NASA/TM-2008-215099 (Corrected Copy)
NESC-RP-06-53/06-032-E

External Tank (ET) Bipod Fitting Bolted Attachment Locking Insert Performance

NASA Engineering and Safety Center Technical Position Paper	Document #: RP-06-53	Version: 1.0
Title: External Tank (ET) Bipod Fitting Bolted Attachment Locking Insert Performance			Page #: 1 of 18

Figure 3.0-1. Insert and Bolt Used in the Design
[ref. Wingate, ET Bipod Fitting Bolted Joint Attachment Design and Locking Insert Performance presentation, June 13, 2006]

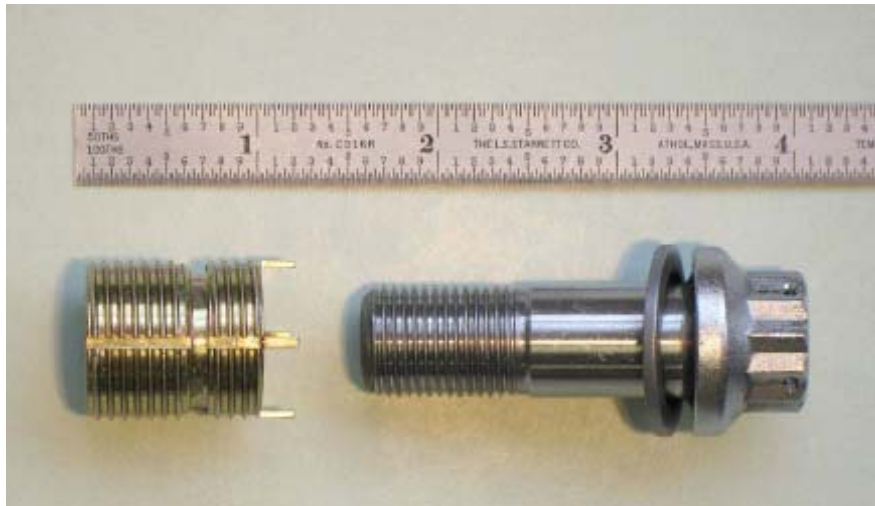
Following STS-107, the External Tank (ET) Project implemented corrective actions and configuration changes at the ET bipod fitting. Among the corrective actions, the existing bolt lock wire which provided resistance to potential bolt rotation was removed. The lock wire removal was because of concerns with creating voids during foam application and potential for lock wire to become debris. The bolts had been previously lubricated to facilitate assembly but, because of elimination of the lock wire, the ET Project wanted to enable the locking feature of the insert. Thus, the lubrication was removed from bolt threads and instead applied to the washer under the bolt head. Lubrication is necessary to maximize joint pre-load while remaining within the bolt torque specification. The locking feature is implemented by thread crimping in at four places in the insert. As the bolt is torqued into the insert the bolt threads its way past the crimped parts of the insert. This provides the locking of the bolt, as torque is required to loosen the joint after clamping. Refer to Figures 3.0-1 and 3.0-2.
